ZONING CHANGE REVIEW SHEET

CASE: C814-2008-0136.02

(North Austin Medical Centre Planned Unit Development Amendment #2)

Staff recommends the 2nd amendment to the North Austin Medical Centre PUD, with redlined notations on the PUD Ordinance No. 20100624-109 and the accompanying land use plan (Exhibit D), to permit changes to water quality requirements, involving drainage and detention within the PUD.

EXHIBIT B - Proposed Plan

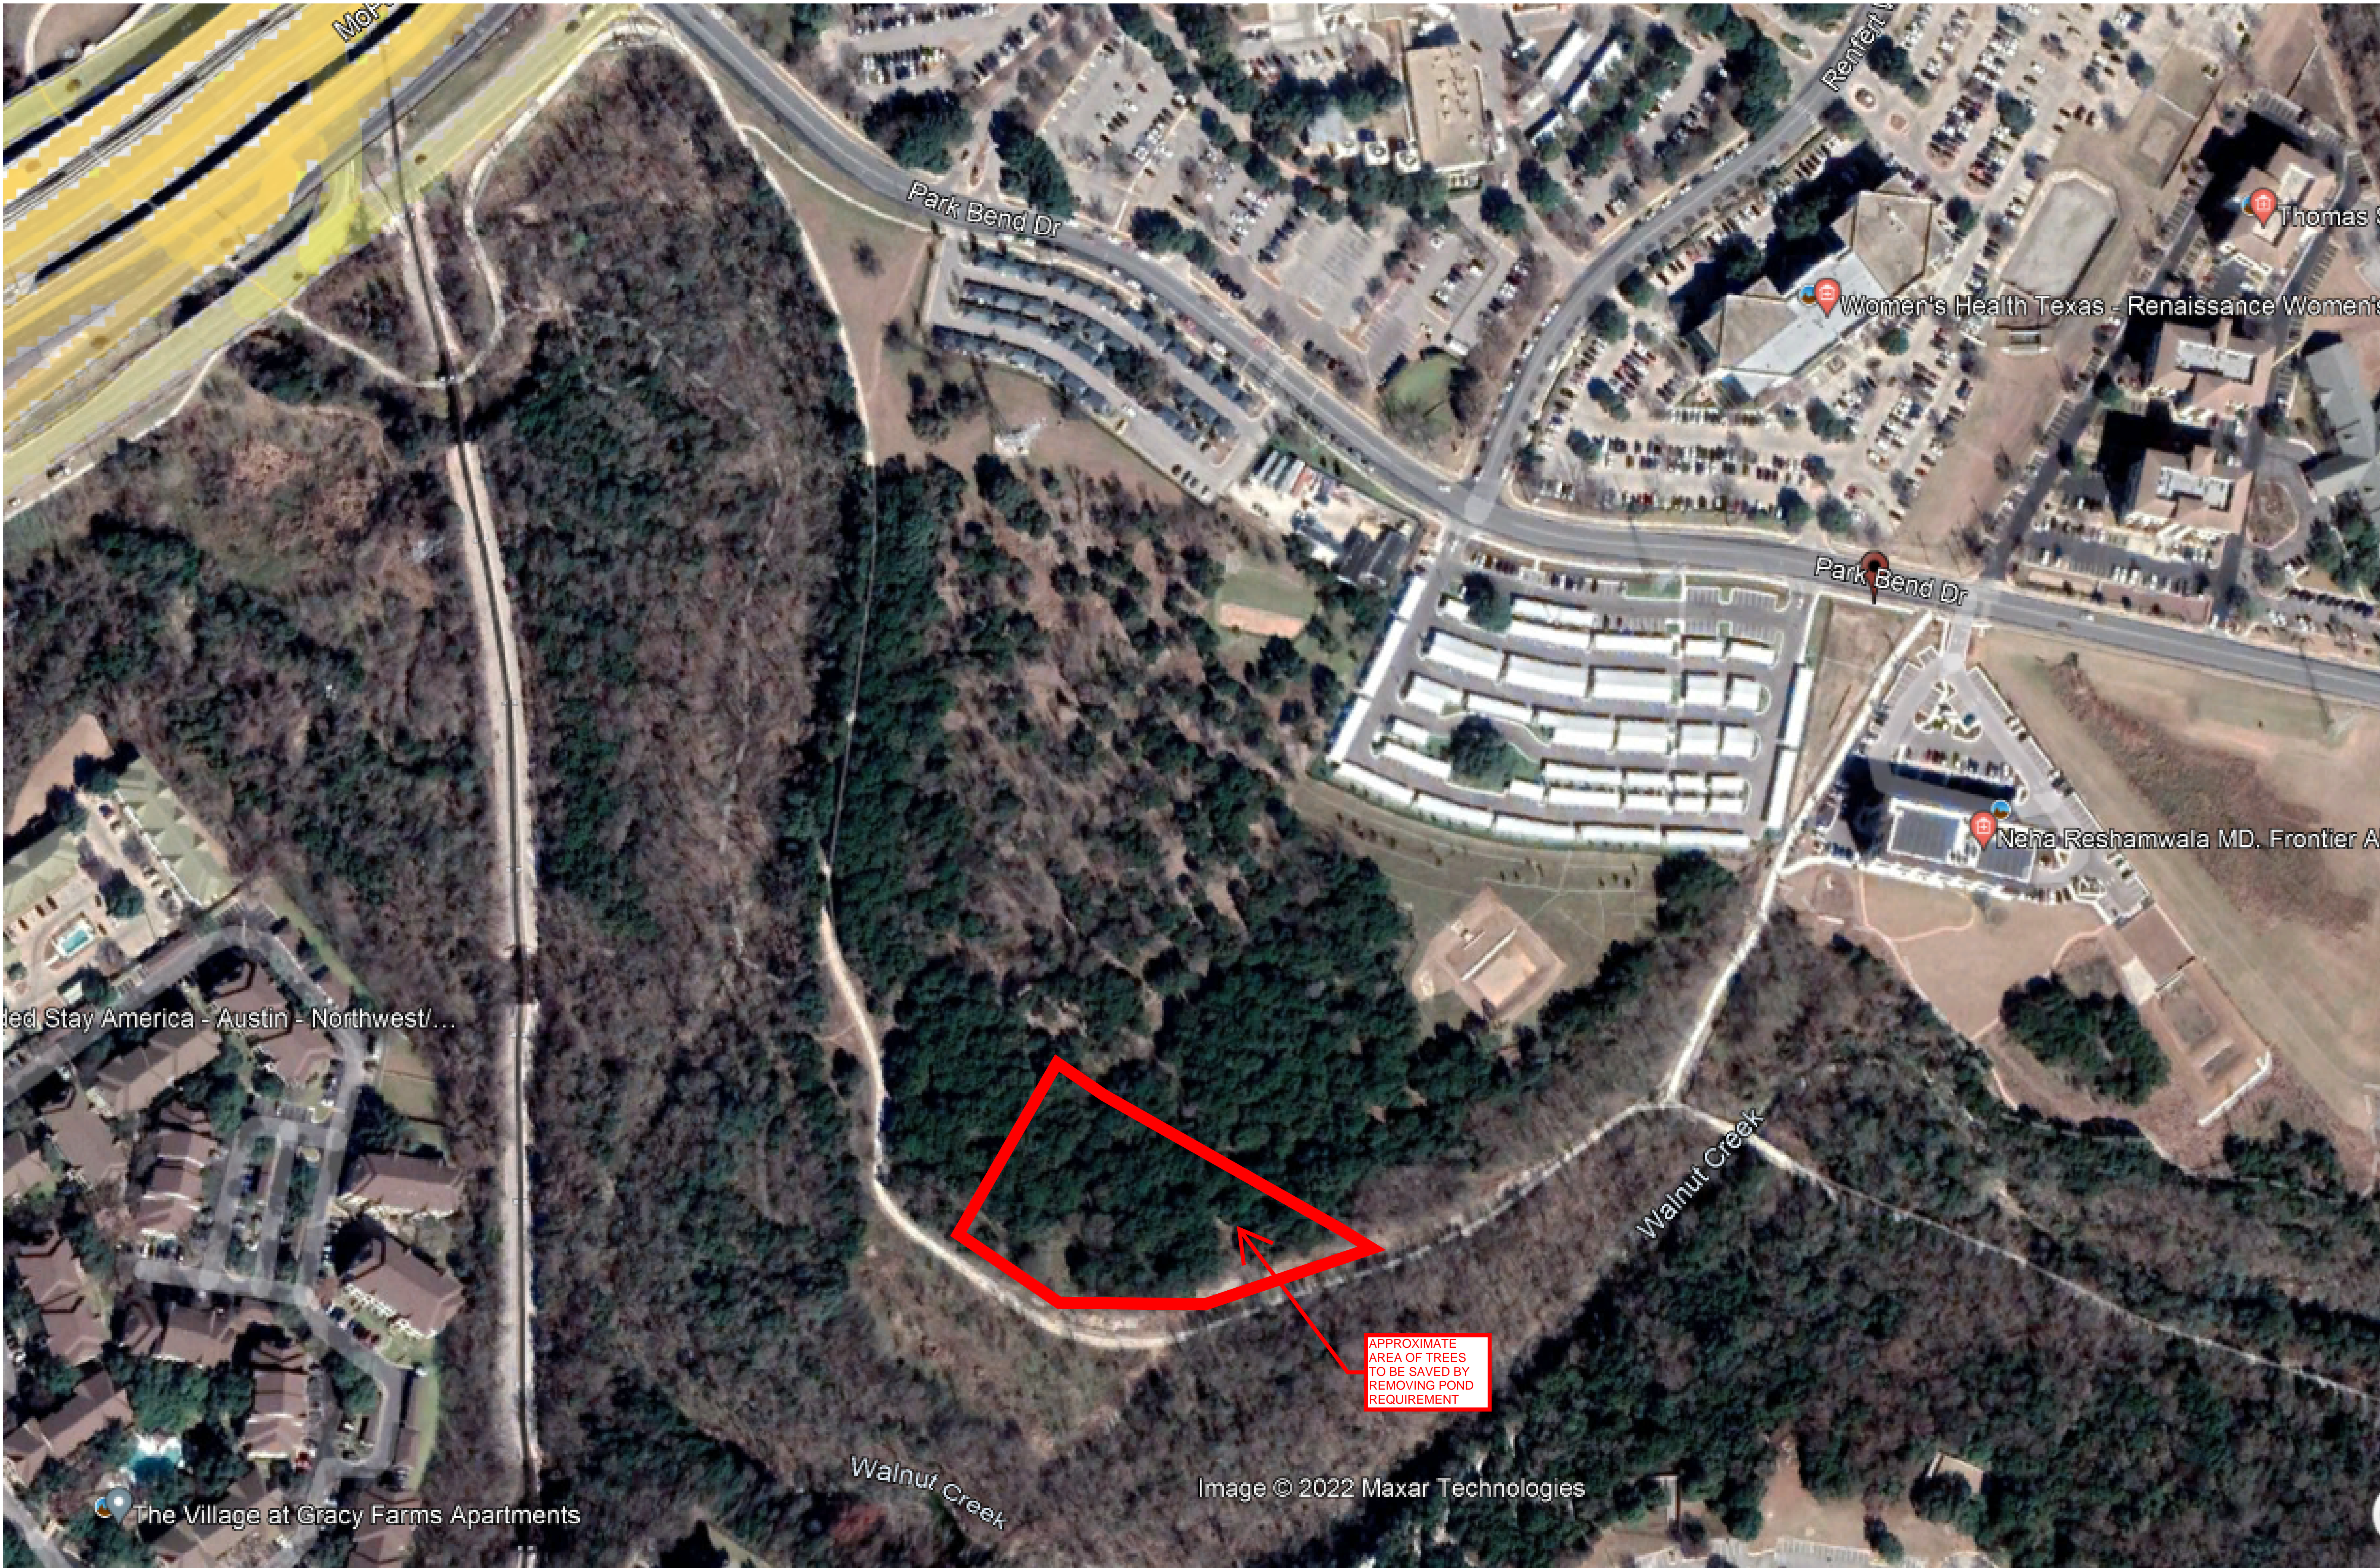
Be sure that the WQTZ and CWQZ creek buffers are shown, labeled, and included in the legend on Exhibit B – Proposed Plan (aka Ex 1 – Option 2 Exhibit). Comments related to uses permitted in the creek buffers is pending.

U1 Comment pending. The WQTZ should be a consistent 300-foot offset from the CWQZ. Please note that per the code of 2008 only water quality controls (no detention) may be in the WQTZ.

On Exhibit B, some things are labeled “existing” and others “proposed.” Clarify what these terms mean in the context of this PUD.

U1 Comment pending. Only water quality controls are allowed in the WQQTZ.

Revise this note to reflect the areas of the CWQZ and WQQTZ as delineated per the regulations of 2008.

U1 Comment pending. A revised version of the relevant exhibit was not provided.

EO1 Update1: Please label CWQZ, CEF/CEF setbacks and location of creek center line on Exhibit B.

EO3 Update1: Provide an exhibit showing the original 21.55 acres of drainage area intended for water quality treatment by the approved pond configuration. In the exhibit, clarify how the approved 21.55 acres of drainage area differs from the proposed 13.65 areas of drainage area using different colors or hatching to differentiate between the two areas.

Response: Critical Water Quality Zone (CWQZ), Critical Environmental Feature (CEF) and Walnut Creek lines and setbacks are shown and labeled. CWQZ and WQTZ comply with 2008 regulations and are defined by PUD Ordinance No. 20100624-109, Exhibit B: Land Use Plan.

Response: Separate exhibits and an overlay have been prepared and attached with this submittal for review.

SHEET NO.
EXHIBIT 1

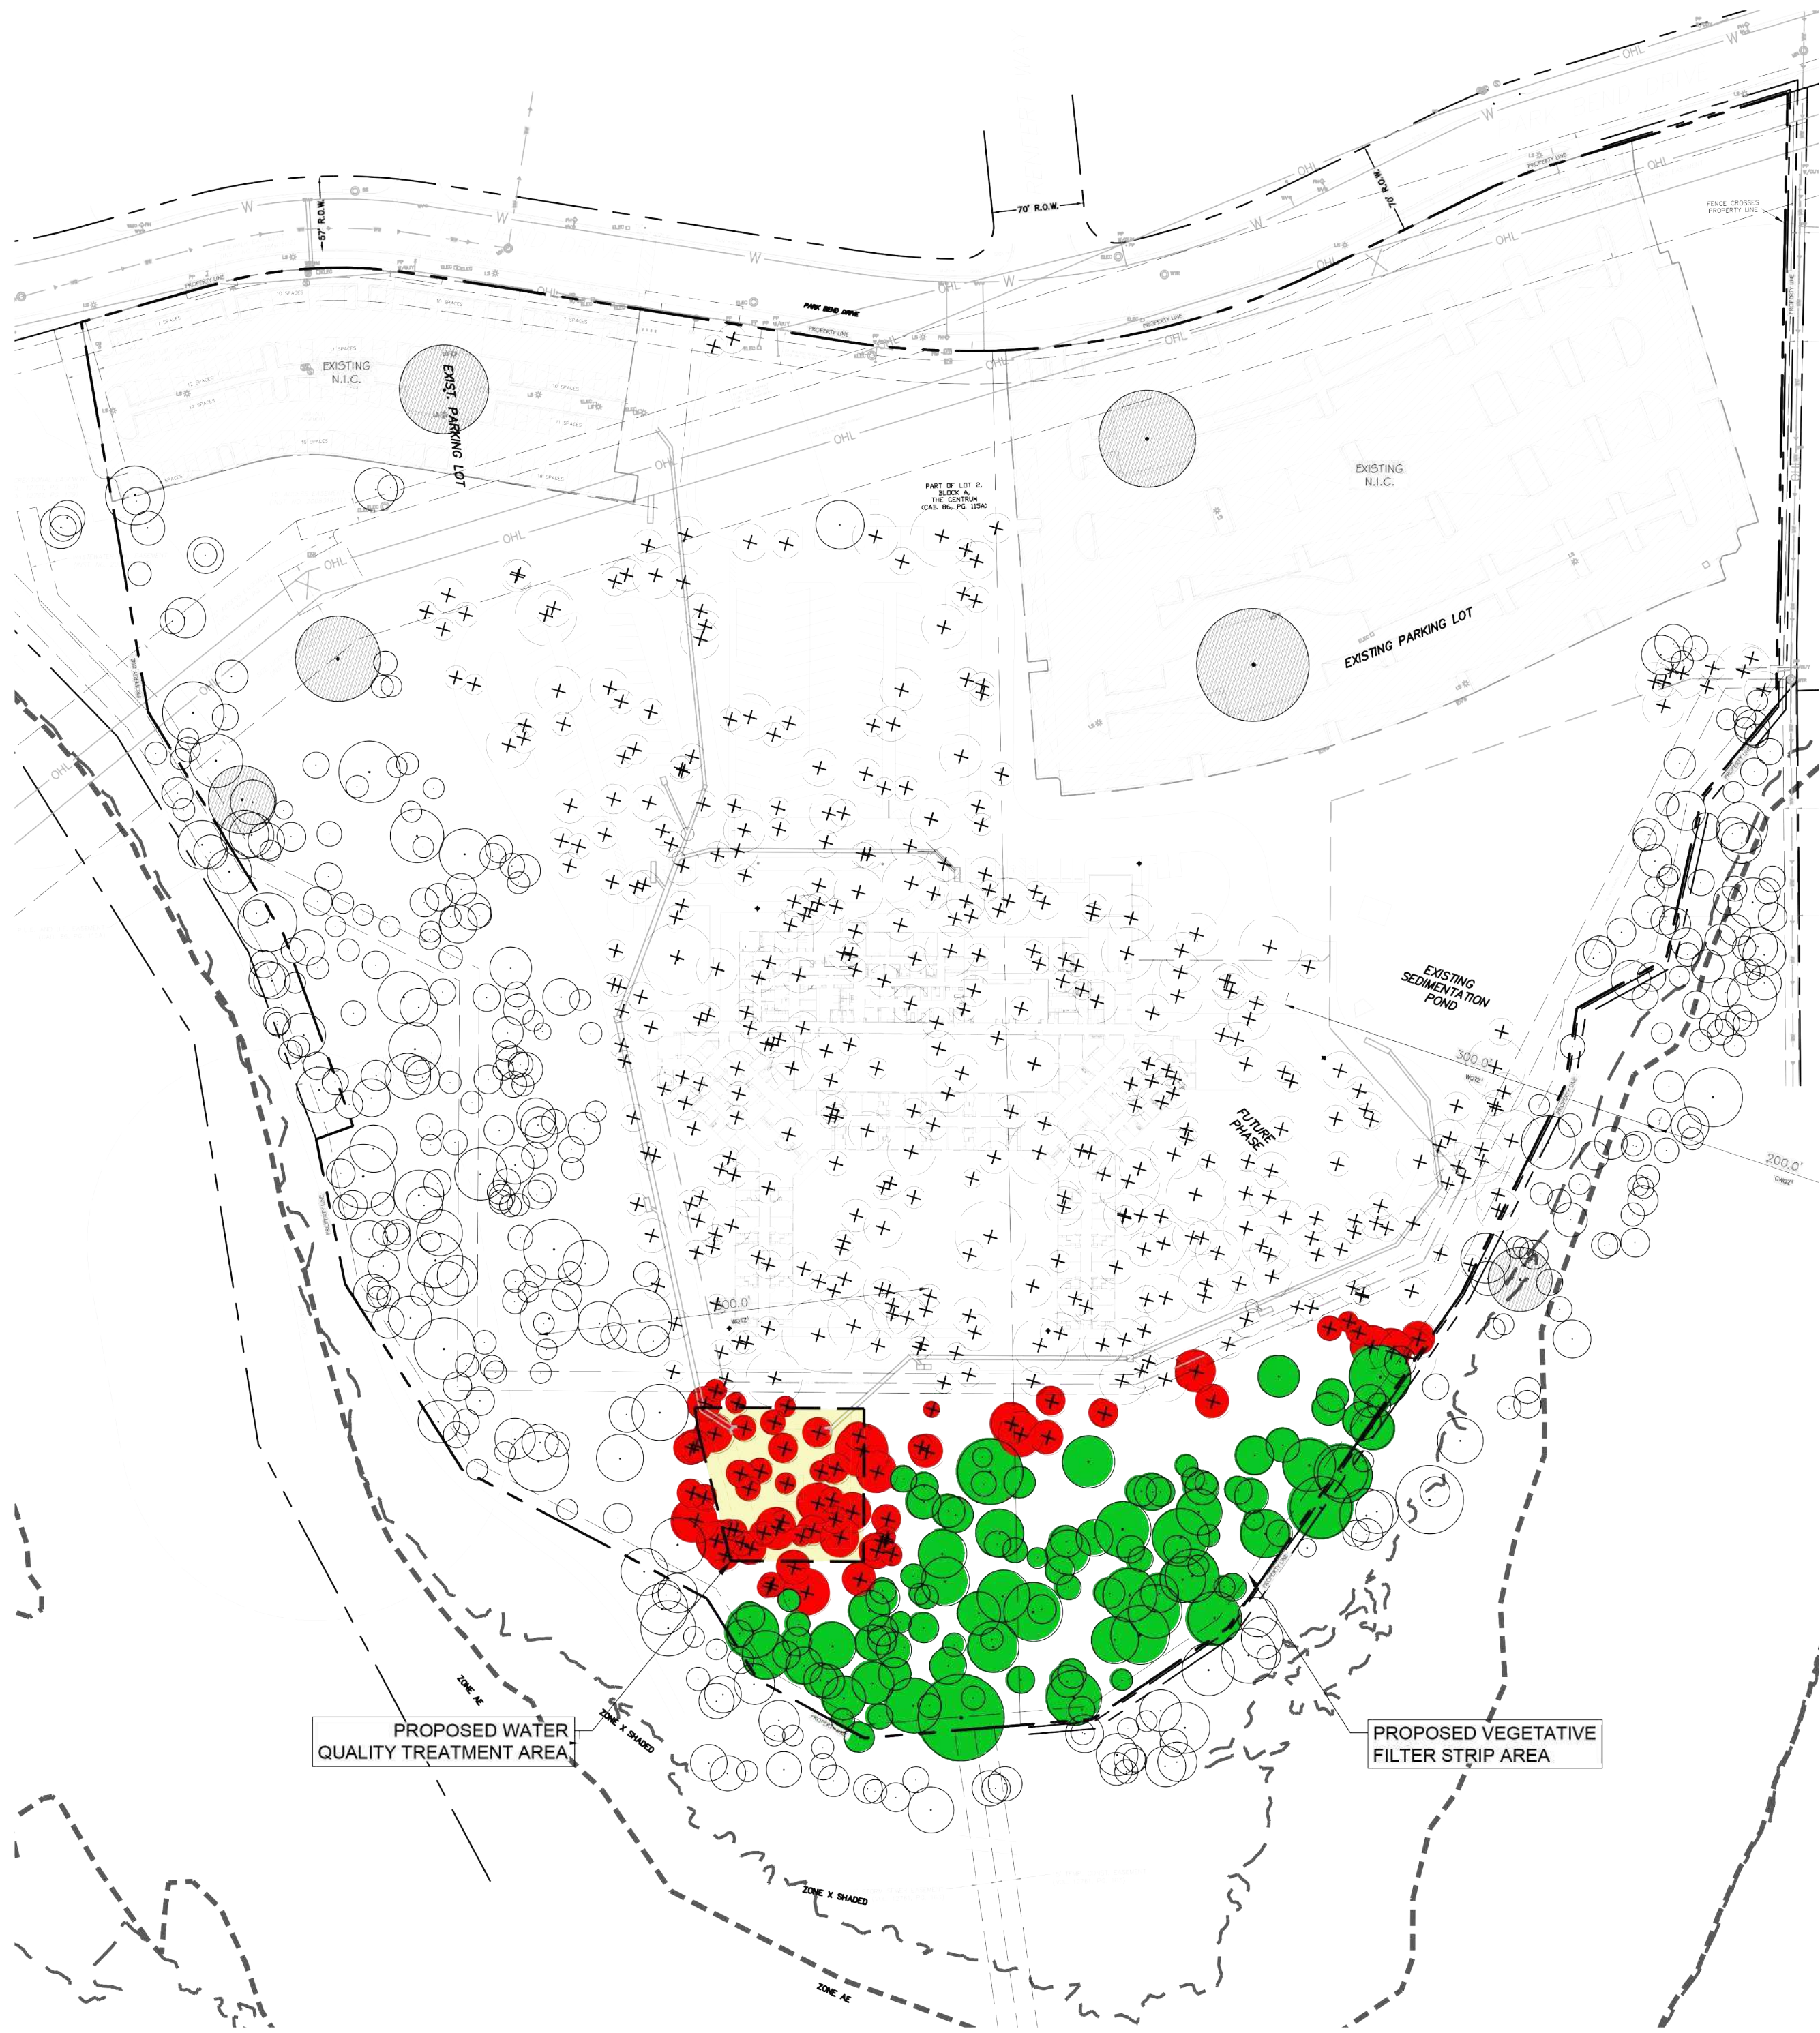
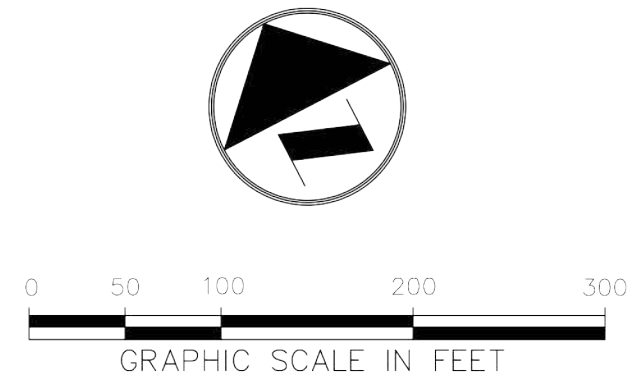
CA 2: Staff is unable to confirm the overall number and sizes of the trees indicated as preserved within the existing pond shown for removal with this amendment. Or, for the smaller pond proposed. There are no species and diameter sizes provided for the tree circles shown. If known, please provide this information for review. If not known, a new tree survey and list will be required to confirm the reduced benefit indicated. If the tree information is greater than 5 years old, a new tree survey and list is required to confirm the reduced benefit indicated.

UPDATE 1: For the exhibit, please highlight in the tree list those additional trees and provide an overall total by size category for those now being preserved with this PUD amendment request. Comment pending.
